NOTICE TO BIDDERS

ADDENDUM #1

Bid #CM-17-18-01-NEC-01 B: North Education Center Site Utilities and Science Modular Plumbing Project
AND

Palomar Community College District

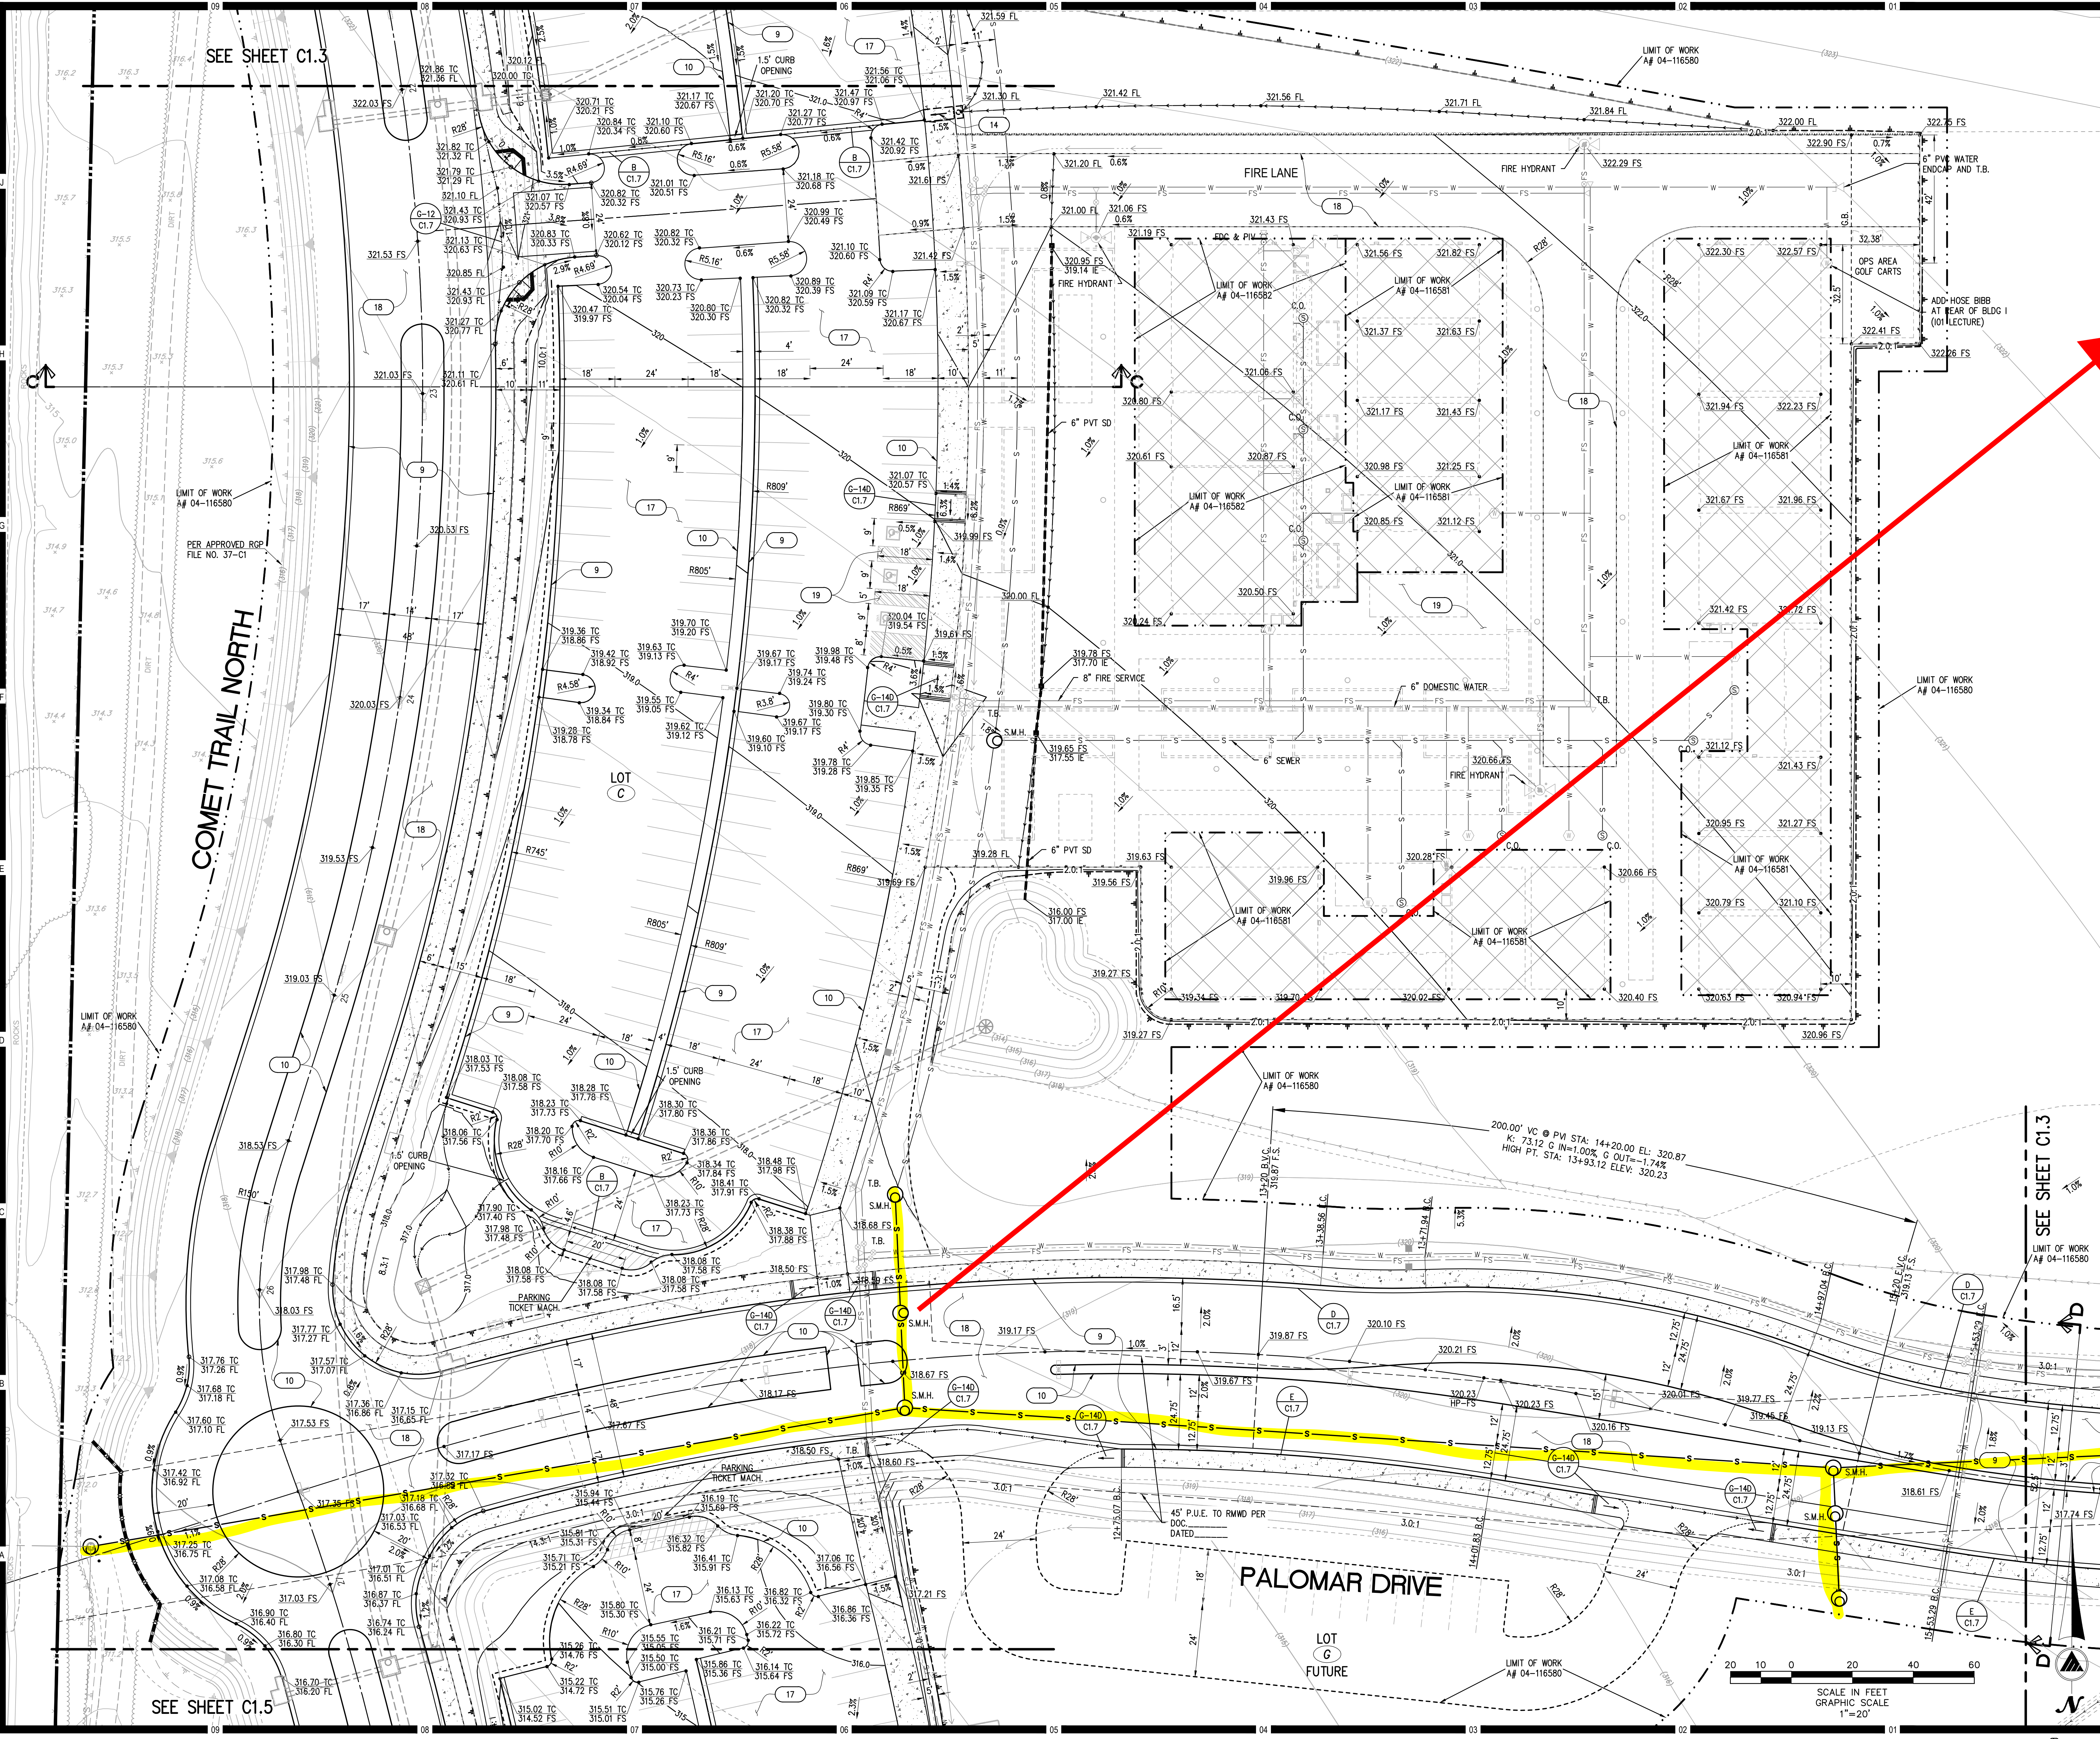
- (7) QUESTION: Please review the attached pages and confirm the highlighted sewer is existing see sheets C1.3 and C1.4 and only the sewer shown upstream of man hole S-5 Station 12+05.52 is new and a part of this scope. See Sheet C3.3 (drawing C1.3 and C1.4 and C3.3)

RESPONSE: Masson RD 11/7/17 - This is correct. MH s-5 and sewer in Palomar Drive is not part of this scope and will be installed by others. [REF Addendum 1 Attachment A]
